PROJECT TITLE: Fastest Emissions ZONE MAP/DRG. FILE # J-21/D43
 DRB#: _____ EPC#: _____ WORK ORDER#: _____

Subject: Traffic Certification
FasTest Emissions, 912 Eubank Blvd, NE,
Plan Check Application No. 0613962

Re: Fastest Emissions, 912 Eubank Blvd NE, Traffic Circulation Layout
Architect's Stamp dated 4-18-07 (J21-D43)

Re: Fastest Emissions, 912 Eubank Blvd NE, Traffic Circulation Layout
Architect's Stamp dated 2-05-07 (J21-D43)

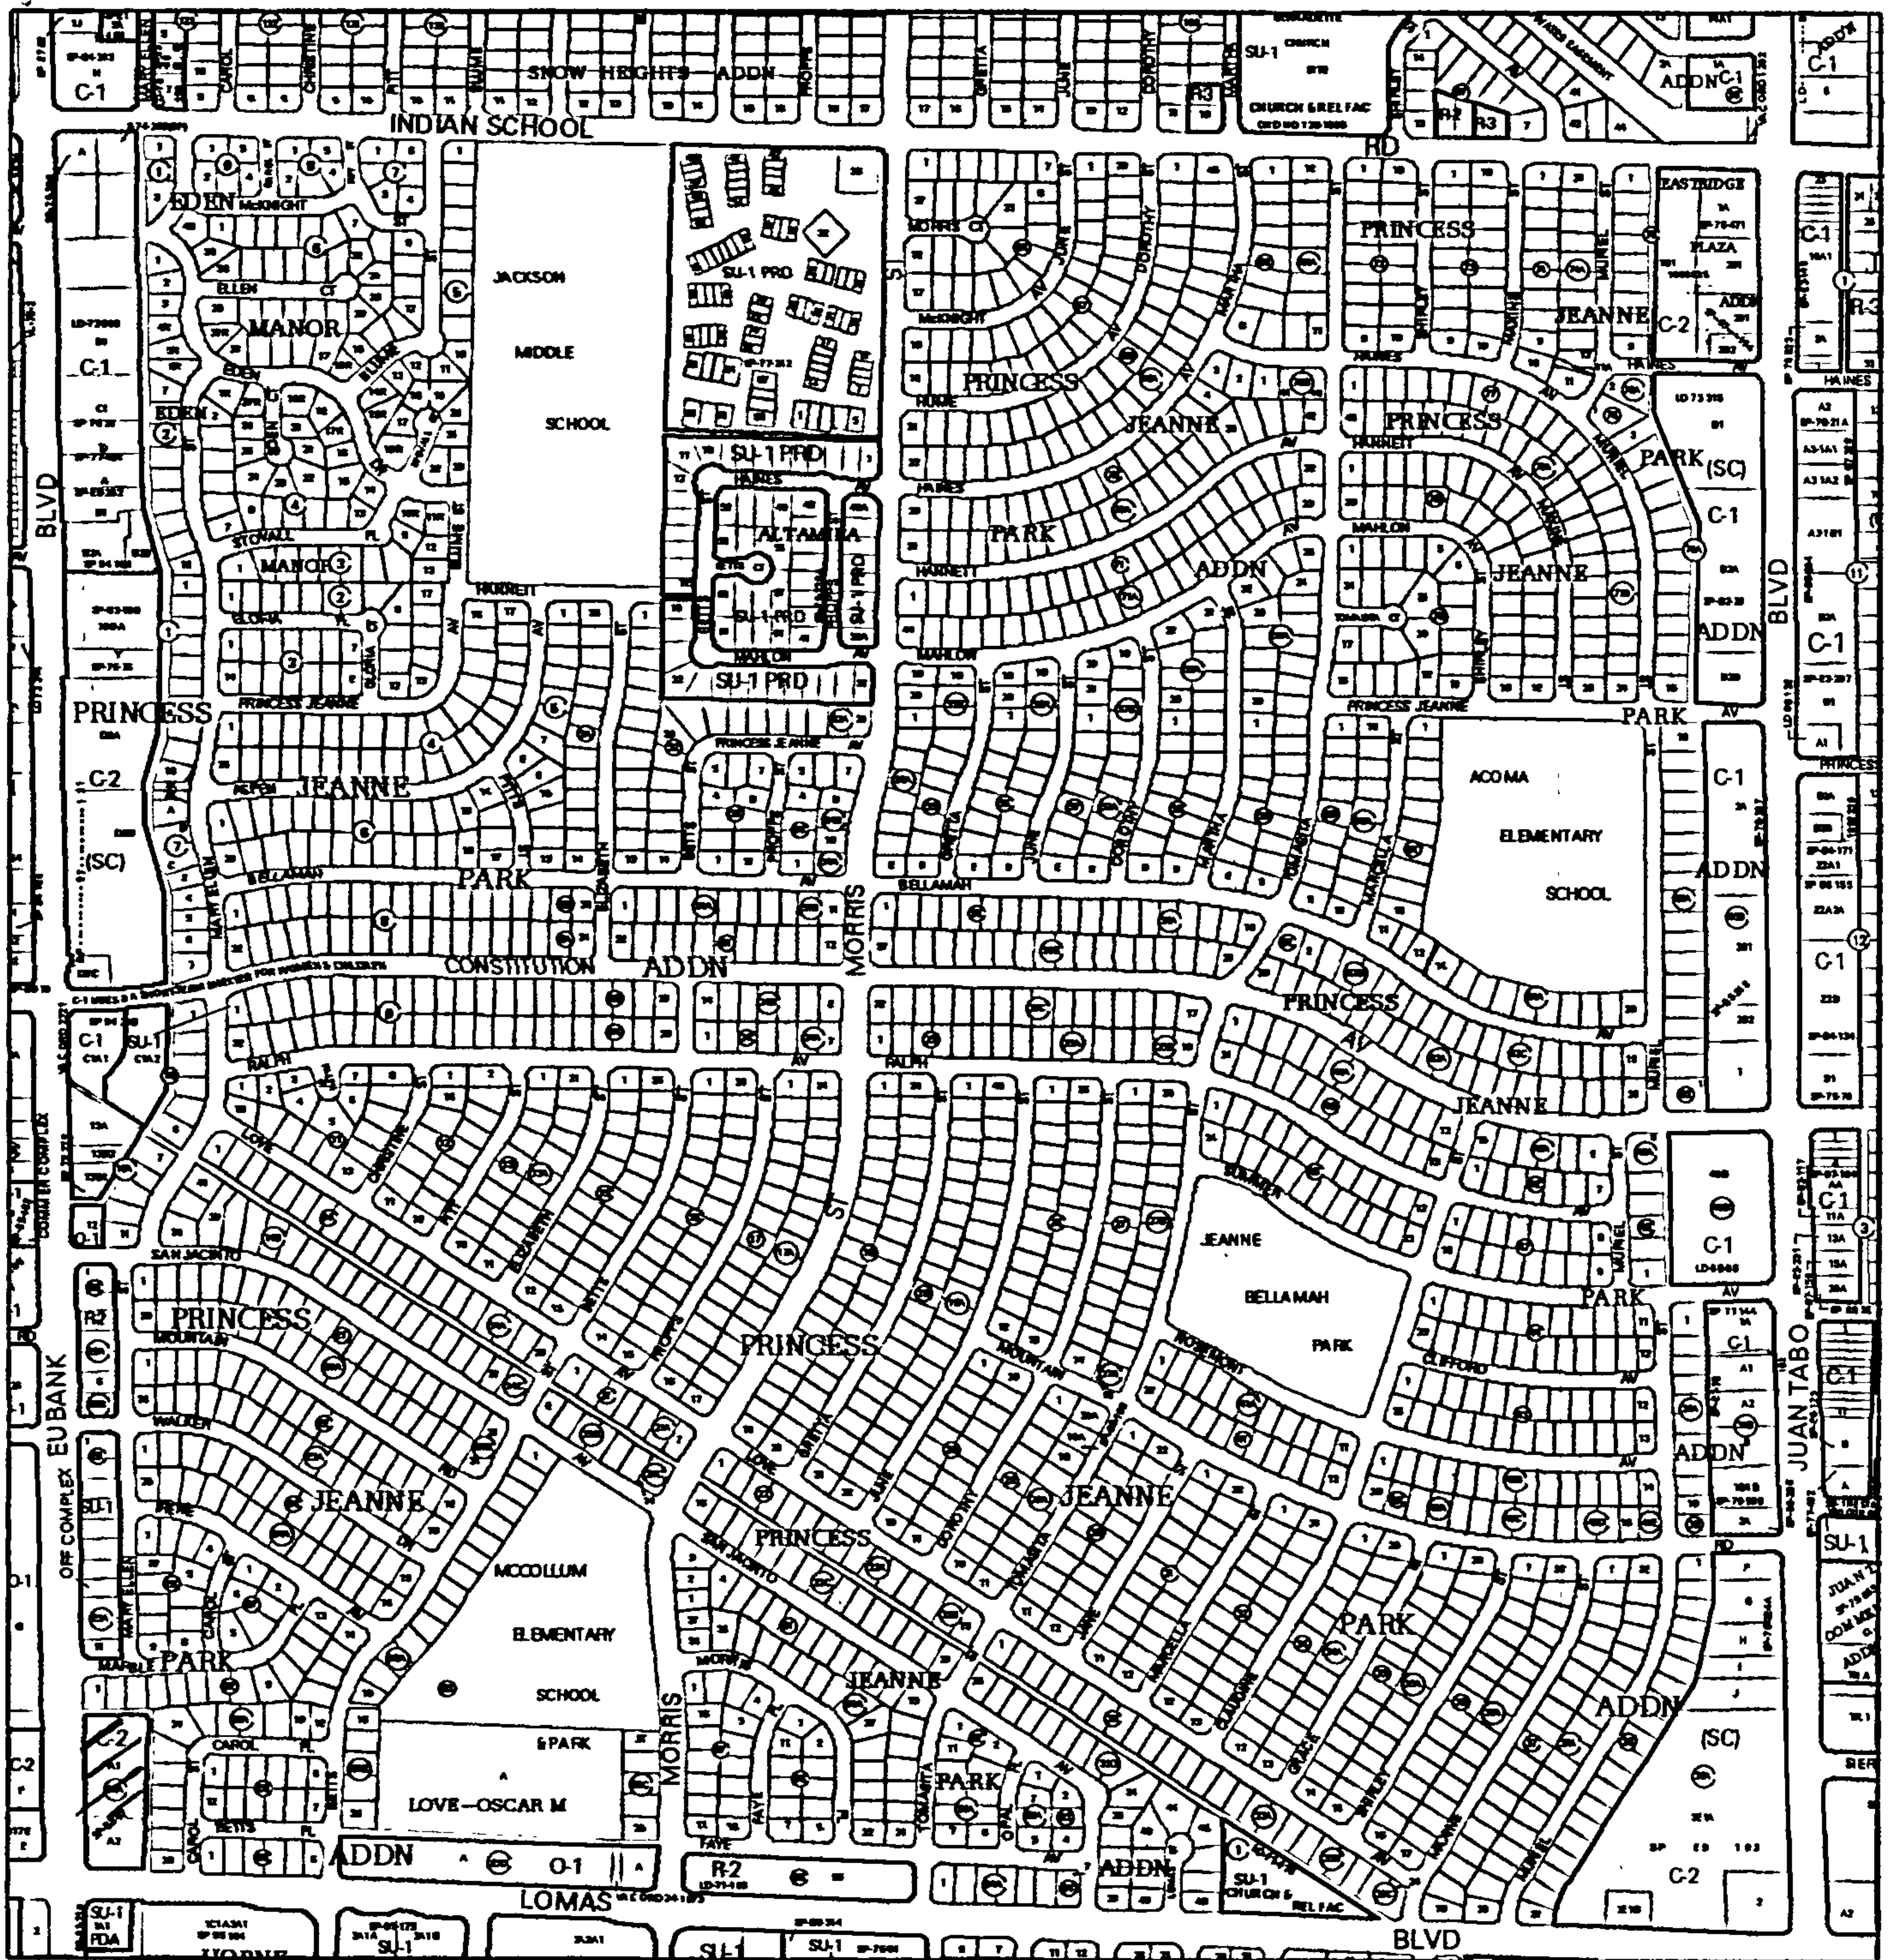
1. On 3/14/07, a site visit was made. The layout shown on your plan is inaccurate in the following areas:
 - The southernmost portion of the site is not undeveloped, nor does it have any dirt portions. A Circle K convenience store / gas station is located in this site. In addition, the information I have on file shows the Circle K to be located within its own lot. Please verify this information, and show the lot lines.

- Your plan shows 10 existing entrances to this site. There are actually only 5 entrances on this site, one of which is located on the Circle K lot.
 - There are fewer parking spaces on the site than shown on the plan. Your plan shows 89 parking spaces within the shopping center, and 11 spaces where the current Circle K is located. The recent site visit shows approximately 75 parking spaces within the shopping center, and 12 spaces at the Circle K. Please rectify this.

- The Los Altos sign is shown in the wrong location.
 - The ATM is shown in the wrong location.
2. Two entrances have curb returns. List the existing radii for these returns.

3. Show the location of all handicapped spaces.
4. Please show the location of the nearest driveway on the adjacent lots.
5. A scale must be shown on the plan. Per the Development Process Manual, Chapter 27, Section 2, Part B.1, only the following scales may be used:

6. A refuse container is located in the project area. Show where this will be relocated, and provide a copy of Solid Waste approval.
7. The addition of a new building will change the requirements for parking spaces. Please list the existing number of parking spaces required by the zoning code, the number of parking spaces required with the proposed addition, as well as the proposed number of parking spaces.

8. List the legal description of the site on the traffic circulation layout.
9. An emissions testing center is considered a drive-through facility. As such, it must comply with the standards as shown in the Development Process Manual, Chapter 23, Section 7, Part E, "Minimum lane widths are 12 feet minimum with a 25-foot minimum radius (inside edge) for all turns. (A 15-foot radius can be used with an increase in lane width to 14 feet)." In addition, an appropriate queuing length of 4 vehicle lengths (80 feet) must be provided. Per Wilfred Gallegos (at 4/5/07 meeting), a dual queue would be acceptable. In addition, the car located inside the facility can be counted as the first car in the queue. Additional geometric information must be provided.

10. Define width of all existing sidewalk.
11. Is there a median break at the site?
